DEVELOPMENT APPLICATION ASSESSMENT REPORT

Application Number:	DA2022/2199
----------------------------	-------------

Responsible Officer:	Maxwell Duncan
Land to be developed (Address):	Lot 20 DP 235980, 19 Sydney Road MANLY NSW 2095
Proposed Development:	Demolition works and construction of shop top housing
Zoning:	Manly LEP2013 - Land zoned E1 Local Centre
Development Permissible:	Yes
Existing Use Rights:	No
Consent Authority:	Northern Beaches Council
Delegation Level:	NBLPP
Land and Environment Court Action:	No
Owner:	Hampic Management Pty Ltd Cinemeccanica Australia Pty Ltd
Applicant:	MHN Design Union Pty Ltd

Figure 1 - Building Height

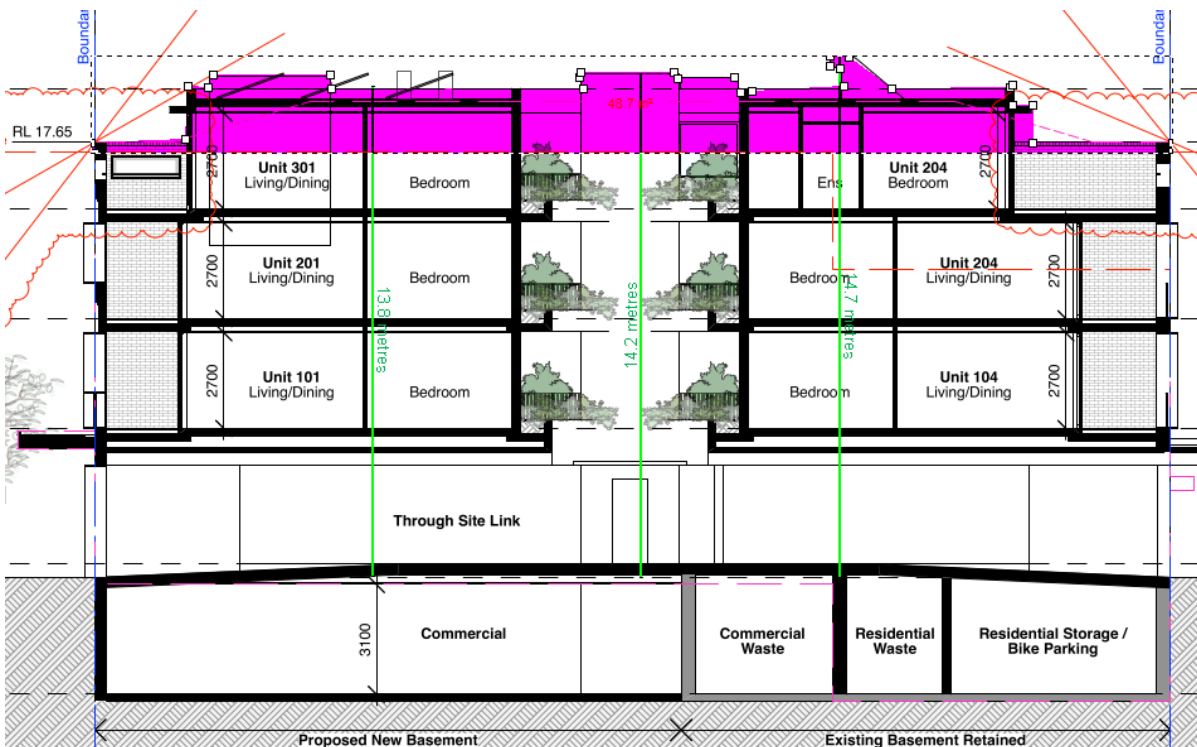
Description of non-compliance:

Development standard:	Height of buildings
Requirement:	12m
Proposed:	13.8m (Roof level 4) 14.7m (Skylight) 14.23m (Top of the lift overrun)
Percentage variation to requirement:	15% - 22.5%
